April 16, 2010  
NRC3-10-0016

Subject: Detroit Edison Company Response to NRC Request for Additional Information Letter No. 25

**Response to RAI Letter No. 25  
(eRAI Tracking No. 4339)**

**Figure II.1-3  
Fermi 3 Site Organization**

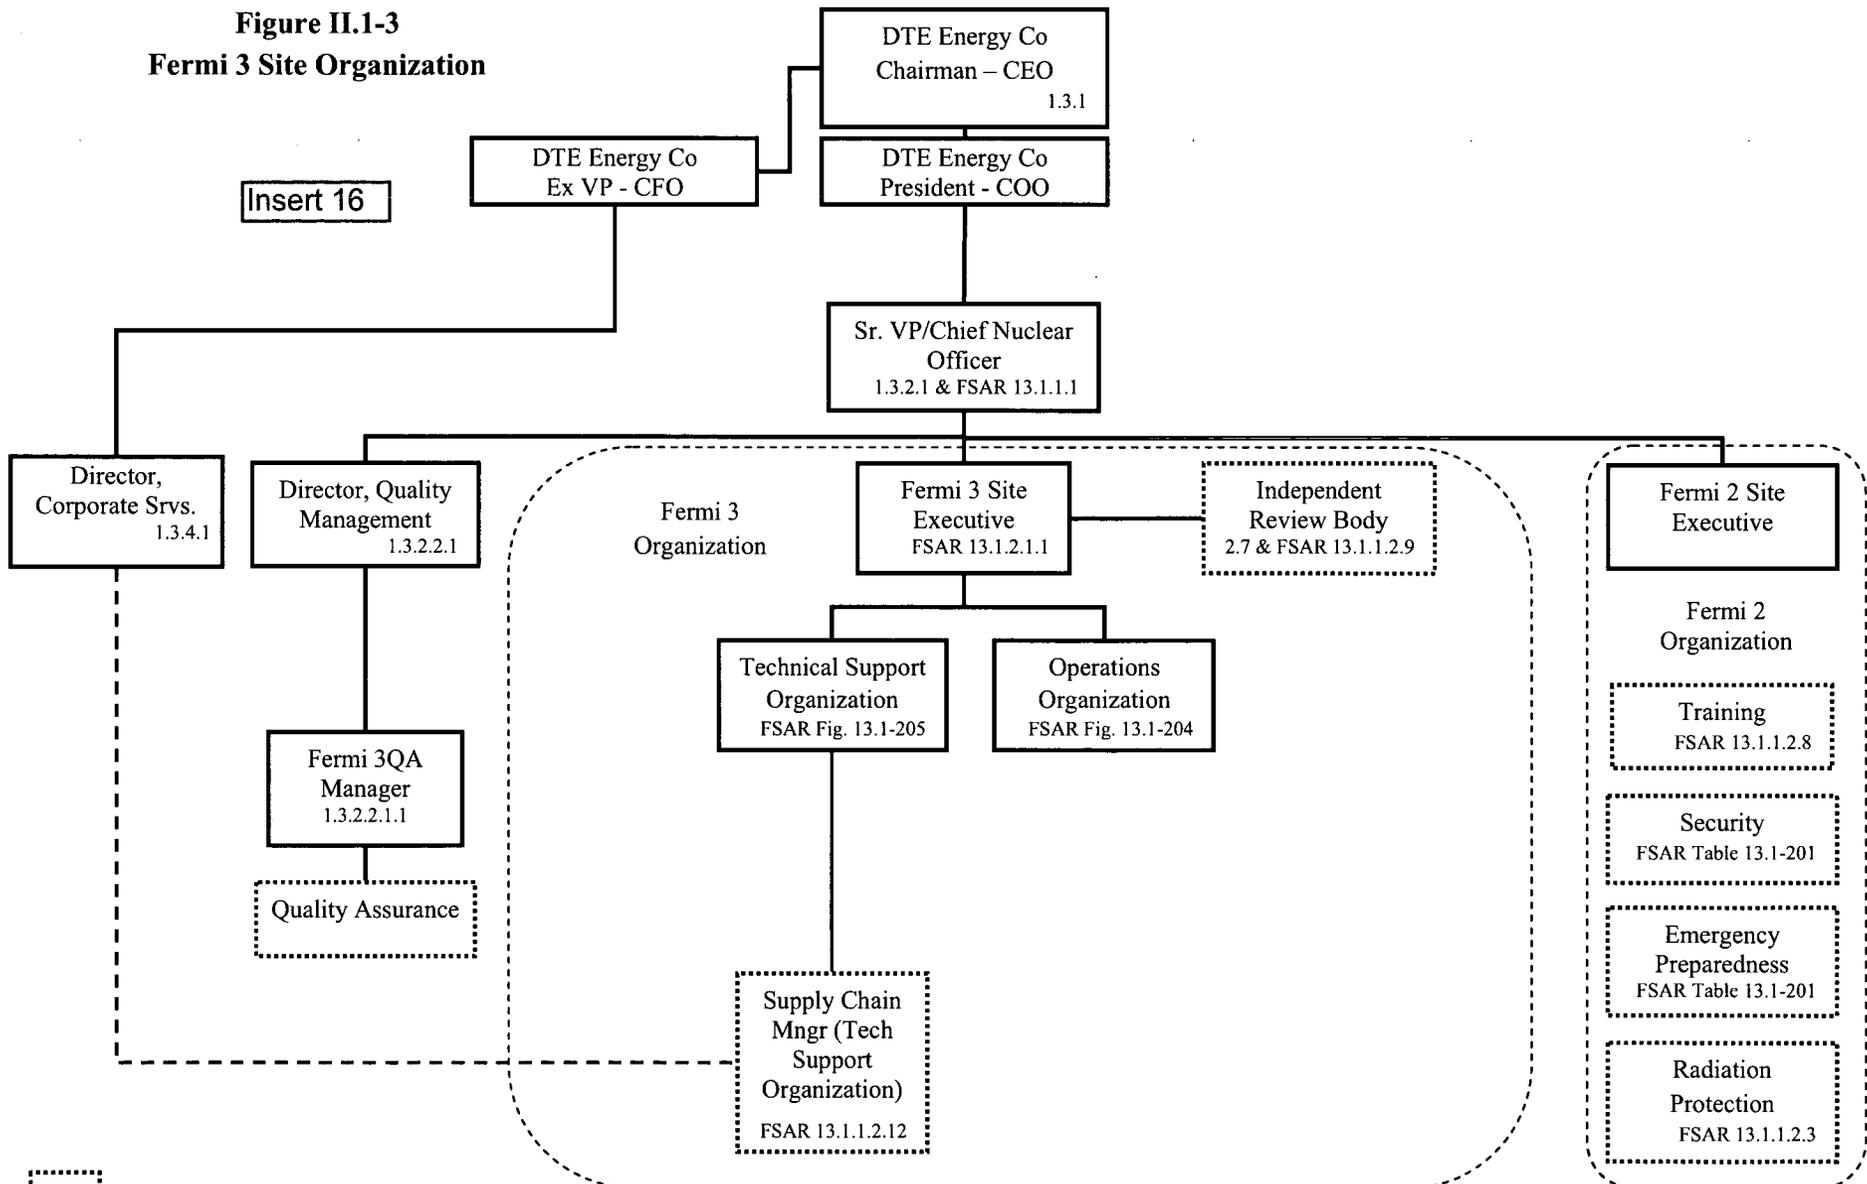
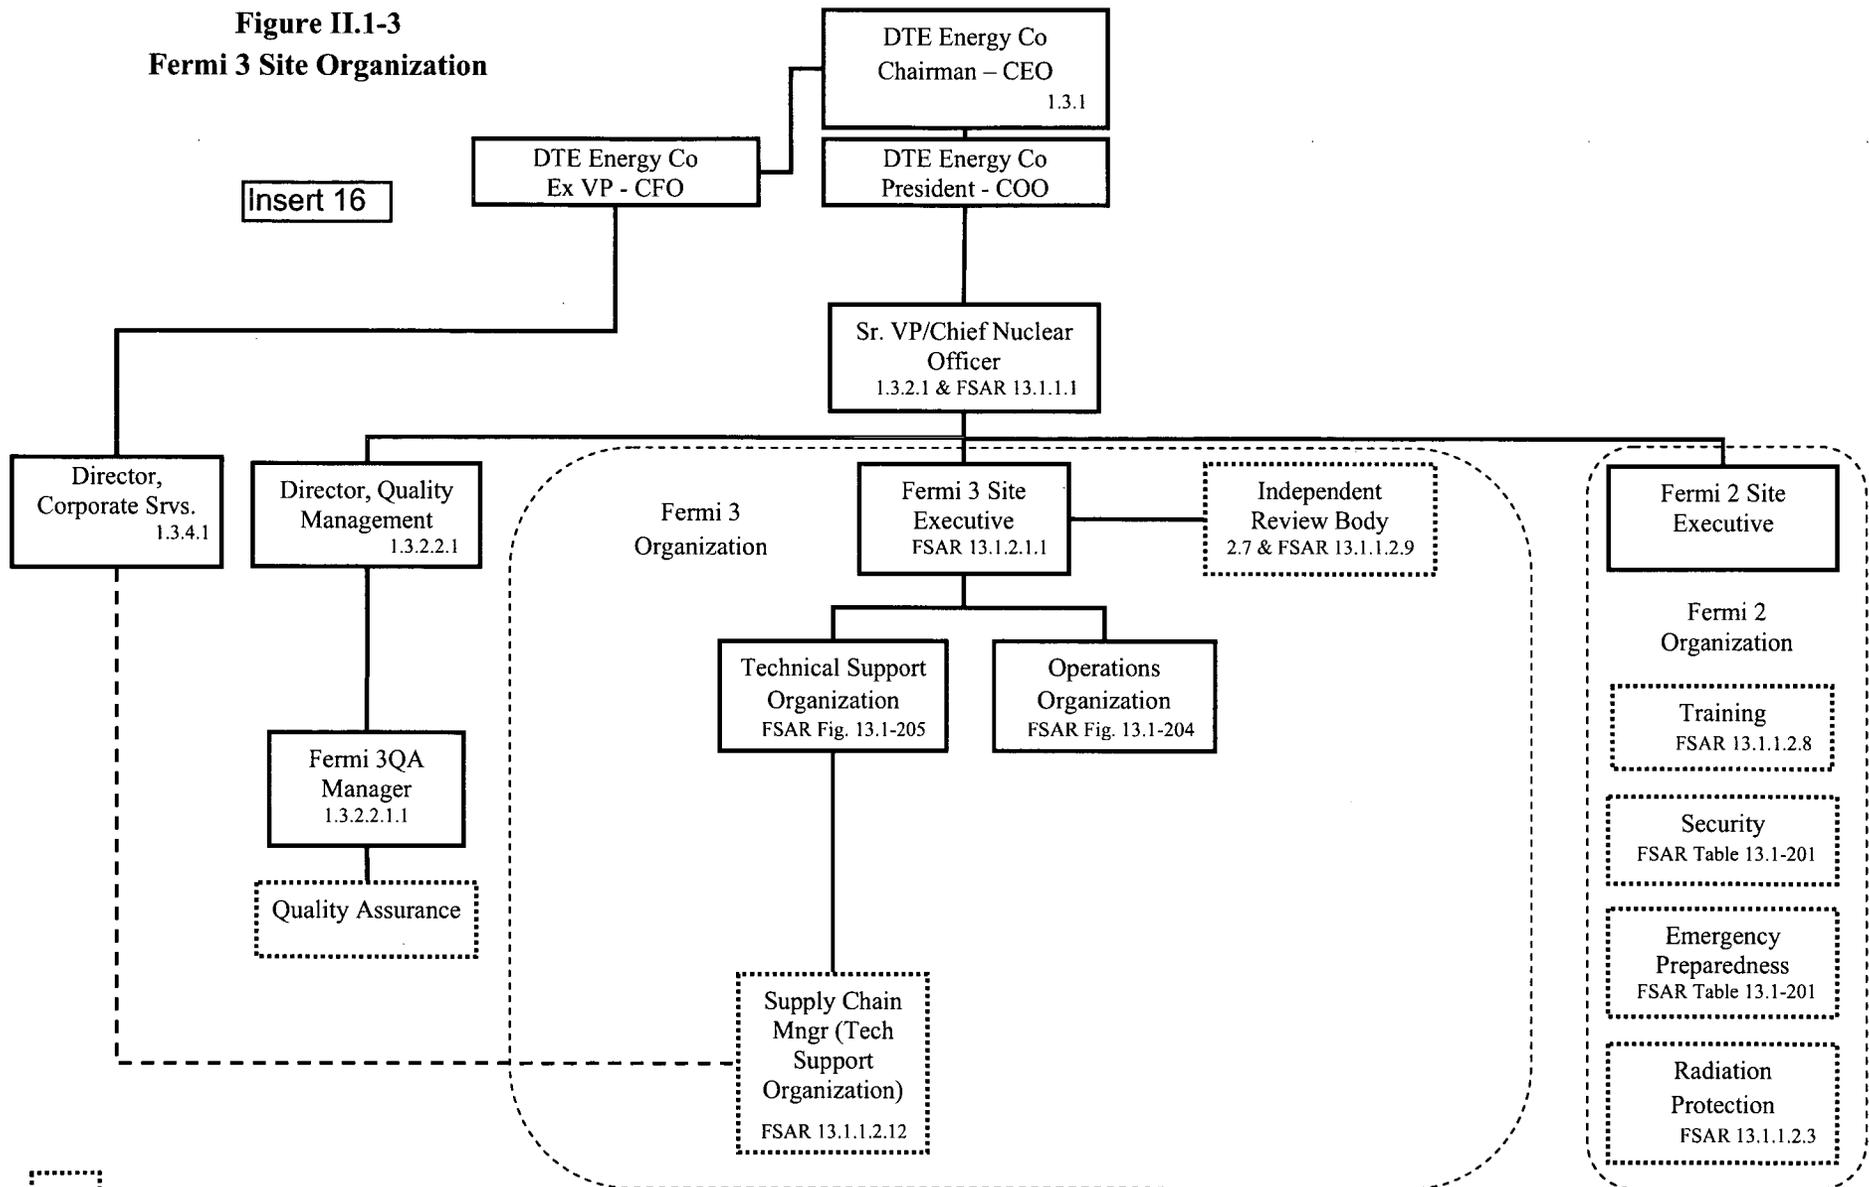
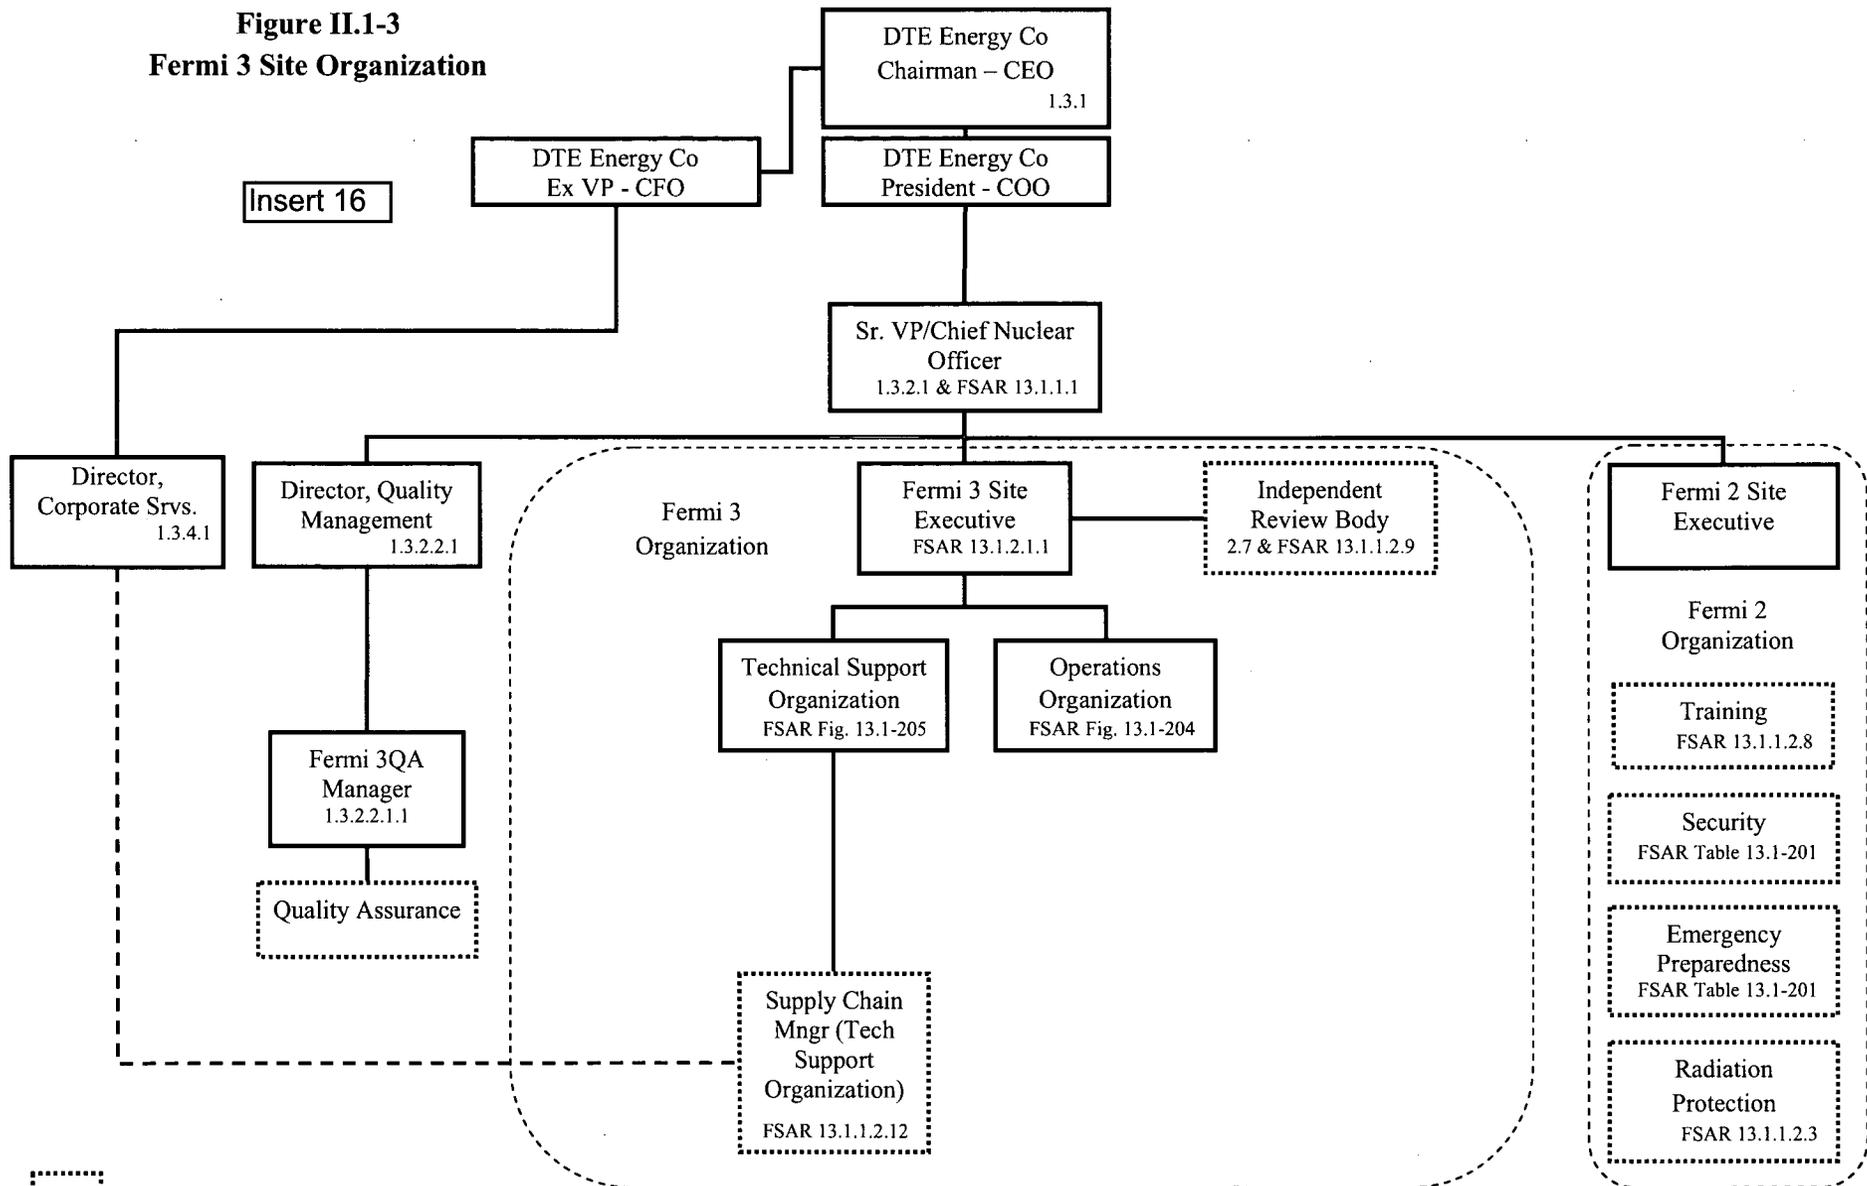
The organizational description presented in Appendix 17AA includes the onsite and offsite organizational elements that function under the cognizance of the Fermi 3 QA program. FSAR Figure 13.1-201 and QAPD Figures II.1-2 and II.1-3 have been revised to identify those organizational elements that are on the Fermi site.

Appendix 17AA, "Fermi 3 Quality Assurance Program Description" Figures II.1-2 and II.1-3 are being revised as shown in the attached markup. Appendix 17AA Figures II.1-2 and II.1-3 are also included in the markup provided with the response to RAI 17.5-12 in Attachment 10.

**Figure 14AA-201 Preoperational and Startup Test Organization (Typical)**

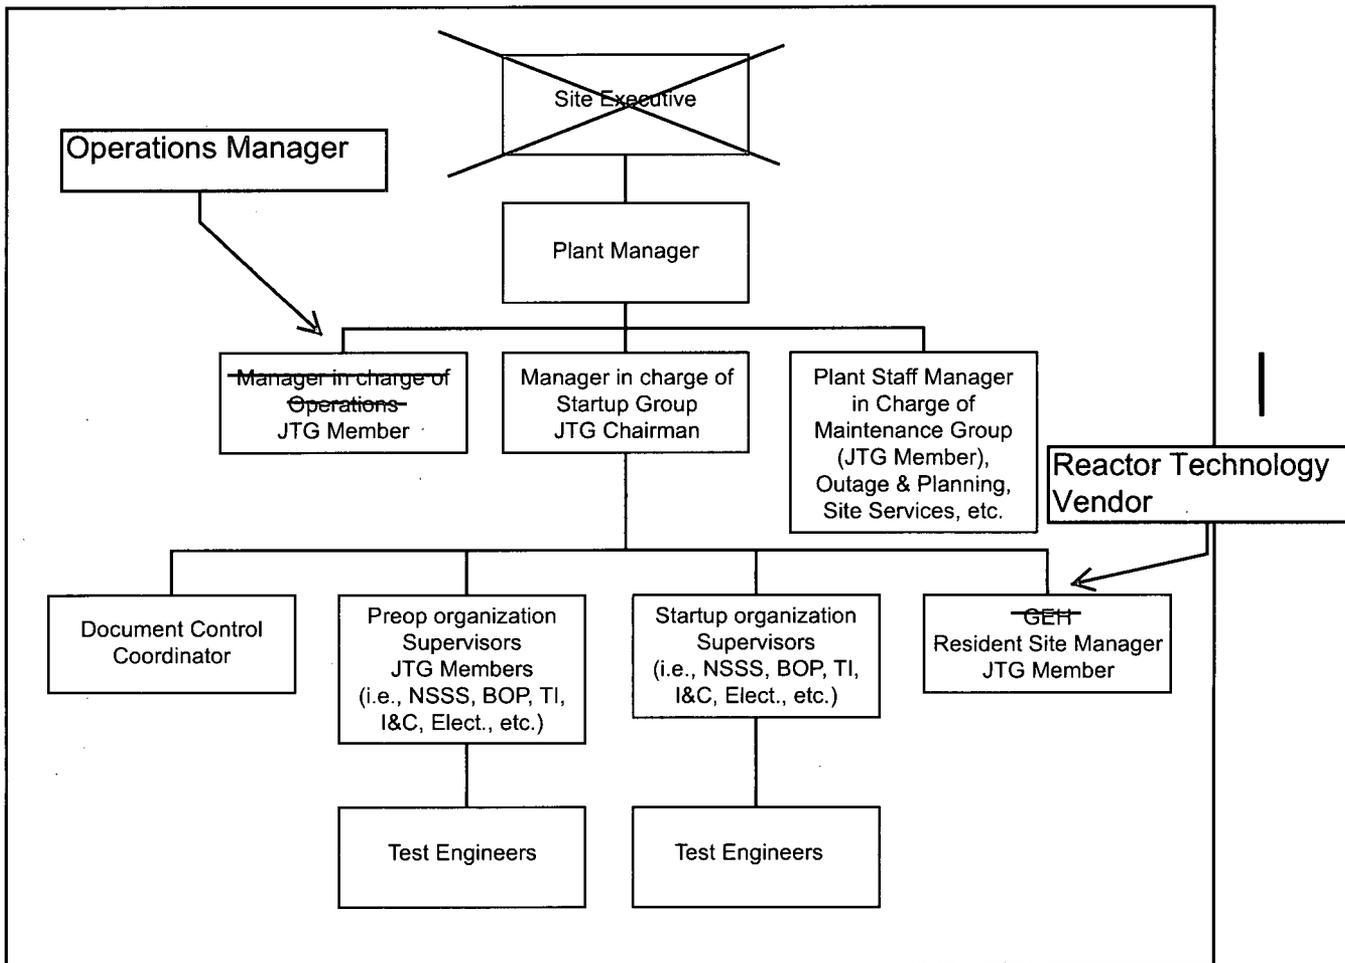
- b. The “Manager in charge of Operations” on Figure 14AA-201 was replaced with the Operations Manager, presented in FSAR Subsection 13.1.2.1.2.1
  - c. The use of “plant staff” throughout Chapter 13 was replaced with “operating and technical support” to reflect the presentation of the operating organization in FSAR Subsection 13.1.2, “Operating Organization” and FSAR Subsection 13.1.1.2, “Technical Support for Plant Operations.”

Figure 2.4-263 Still Water Elevations

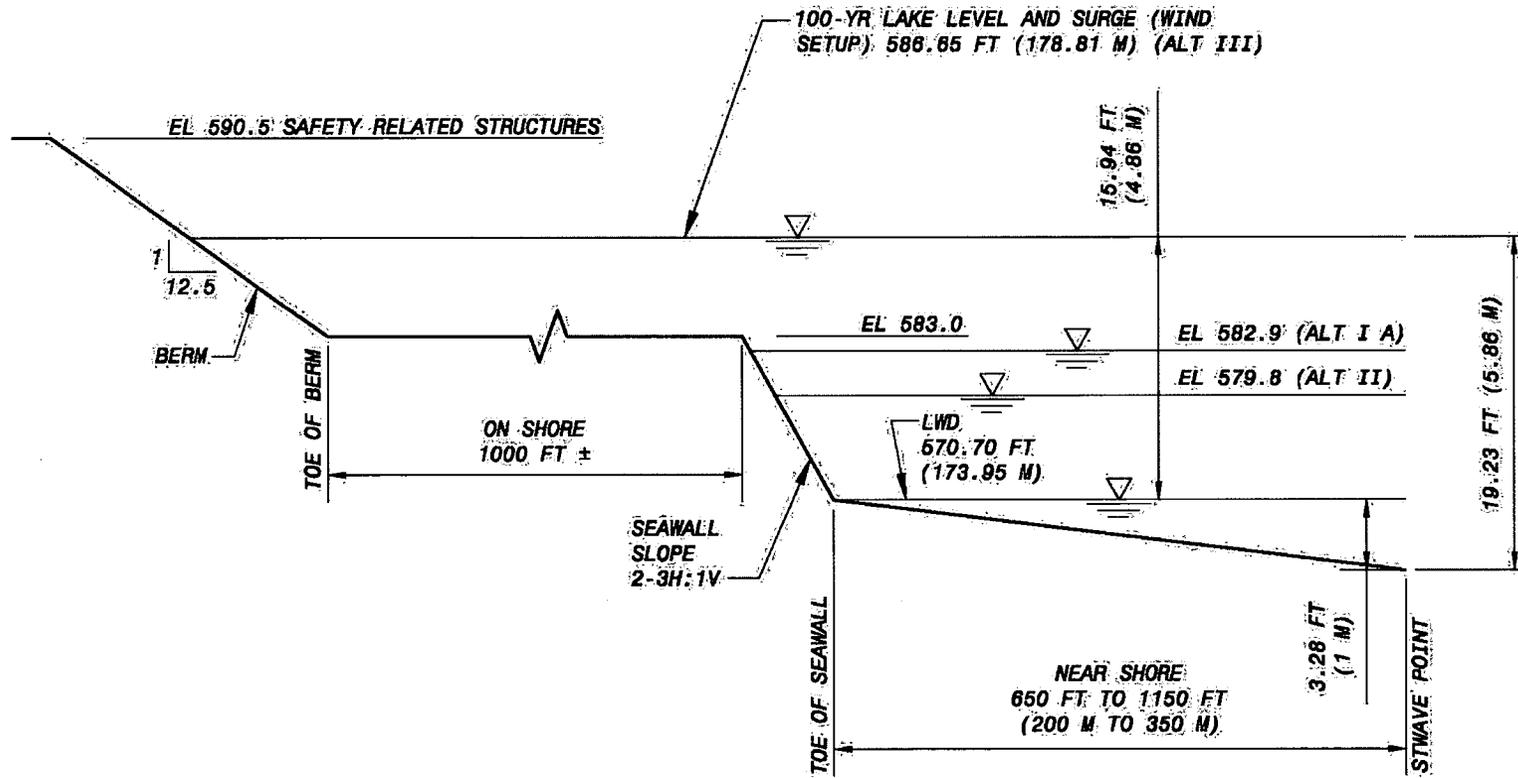
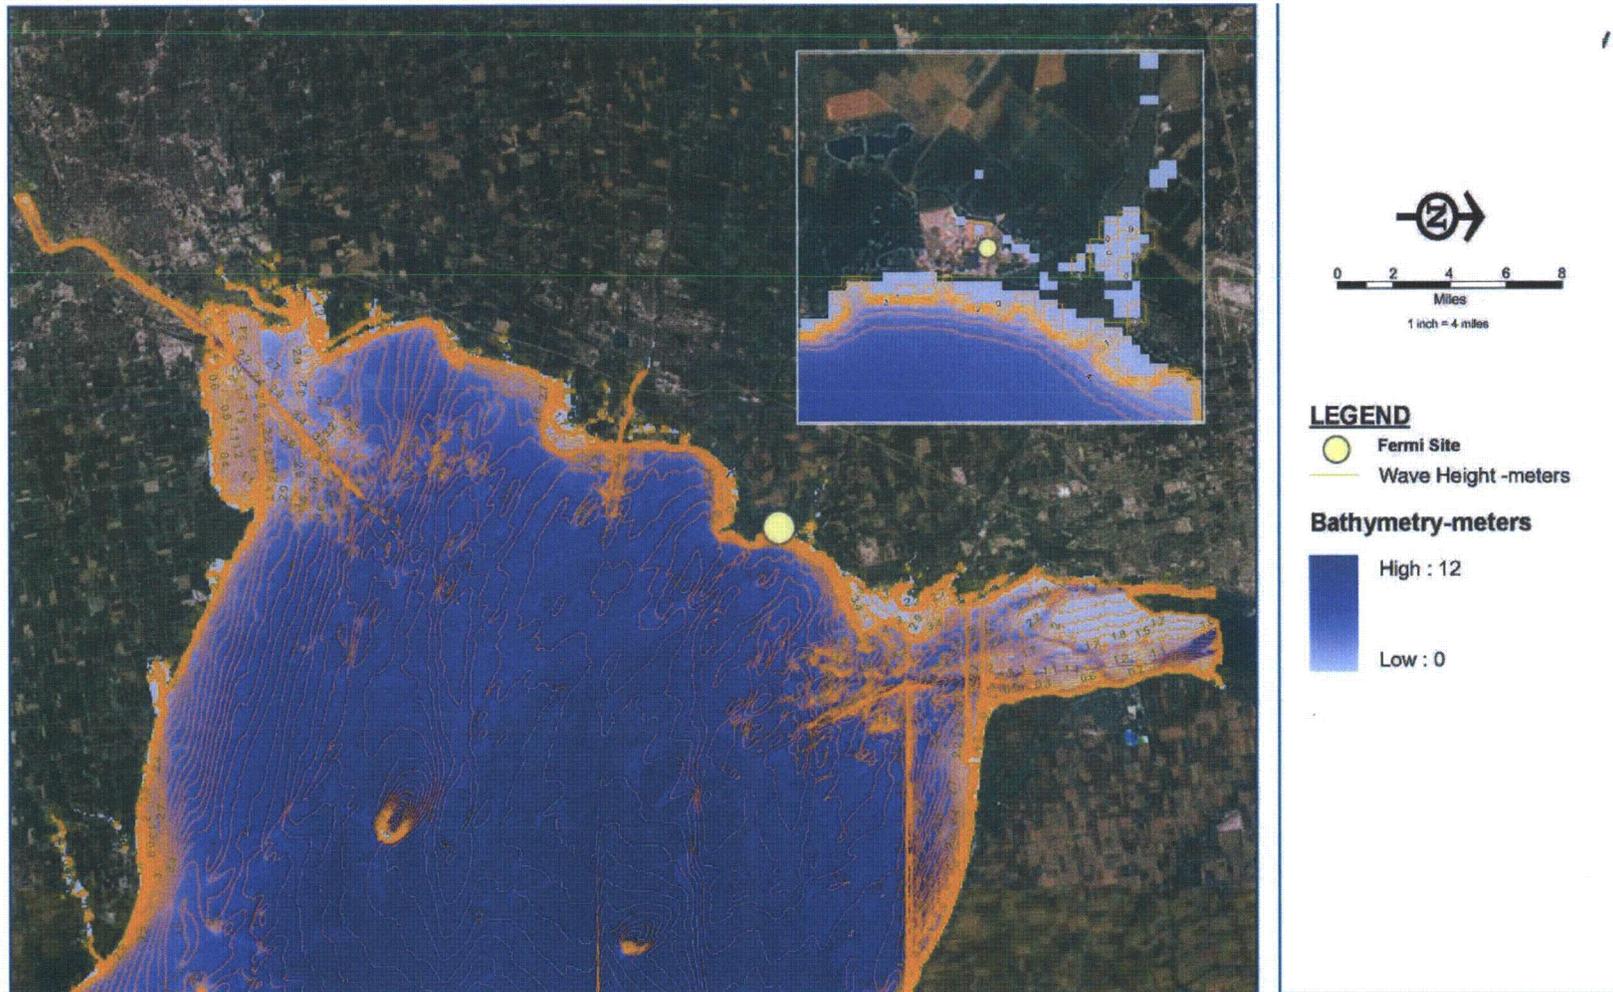
FSAR Sections 2.4.3 and 2.4.5 along with FSAR Figures 2.4-263, 2.4-264, and 2.4-265 have been updated to reflect the analysis as presented in response to NRC RAI Letter No. 19.

Figure 2.4-263 shows the still water elevations for all three alternatives. On Figure 2.4-263 the seiche height of 6.3 ft was used in place of the 100-year storm surge of 4.0 ft for Alternative I (identified as Alternative IA). Alternative III has the highest still water level of all alternatives evaluated. The other alternatives vary between 1.1 to 2.1 m (3.8 to 6.8 ft) less than Alternative III.

Figure 2.4-264 provides the contours of the wave height distribution overlaid on the bathymetric map of Lake Erie from NOAA (Reference 2.4-317). The wave height contours were prepared using the results from the STWAVE analysis. Wave heights are in meters and the contours have 0.1 meter accuracy.
